WEST VIRGINIA DEPARTMENT OF ENVIRONMENTAL PROTECTION WV OIL AND GAS CONSTRUCTION STORMWATER PERMIT

FACILITY NAME:	Mountain Valley Pipeline	Project	REG.#	EXPIRE DATE:		
PERMITTEE	MOUNTAIN VALLEY I	PIPELINE, LLC	WVR310667	12/1/2020		
ADDRESS/PHONE:	Attn: MATTHEW HOOV	/ER				
	625 LIBERTY AVE, ST	1700				
	PITTSBURG, PA 15222

PERMIT / SITE EVALUATION

Location on Spread E of complaints 1-8.

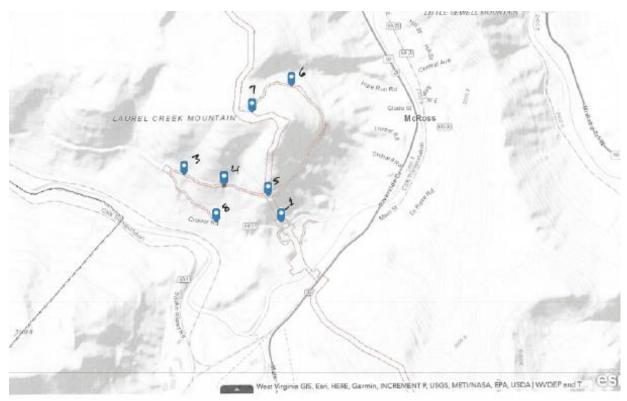
Complaint 1: ROW at Crozier Rd. BMPs were in place and final restoration is ongoing.

Complaint 3: AR 182. Controls were in place to protect receiving wetland; road was adequately stabilized.

Complaint 4: AR 182. No significant noncompliance was noted. Recommended additional stone on roadway at water crossing and protection on the downslope side of roadway.

Complaint 5: Intersection of AR 182 and ROW at St. 7596. Controls in place. Waterbars in place upgradient of open pipe trench both above and below AR 182.

Complaint 6: Bridge crossing wetland on AR 182. CFS in place on both ends of bridge and roadway is stabilized. Filter fabric along the side of bridge is in disrepair but also unnecessary. Recommended removal of bridge filter fabric.

Complaint 7: Northern terminus of AR182. Sediment loss of ROW was address in a previous inspection conducted by Jason Liddle. BMPs in this area have been significantly enhanced and sediment deposits have been remediated. The land disturbance in the area of the ROW has been put to final grade and stabilization measures have been initiated.

Complaint 8: Southern terminus of AR 182. BMPs were adequate, no impact to UNT of Meadow River was noted.

Location on Spread E of complaints 9 and 10.

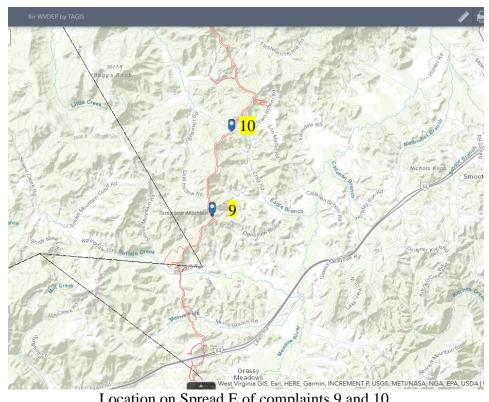
Complaint 9: St. 8100 of ROW. Project at final grade with stabilization measures being initiated. BMPs for this phase of the project have been installed per the SWPPP.

Complaint 10: St. 8002+43 of ROW. BMPs in place in this area. There was evidence of stormwater discharging offsite into a large vegetative buffer, on a mild grade, far away from any receiving waterbody. There was a small amount of mulch present beyond the LOD. After a discussion it was agreed to add another layer of E and S control as an enhancement for assurance.
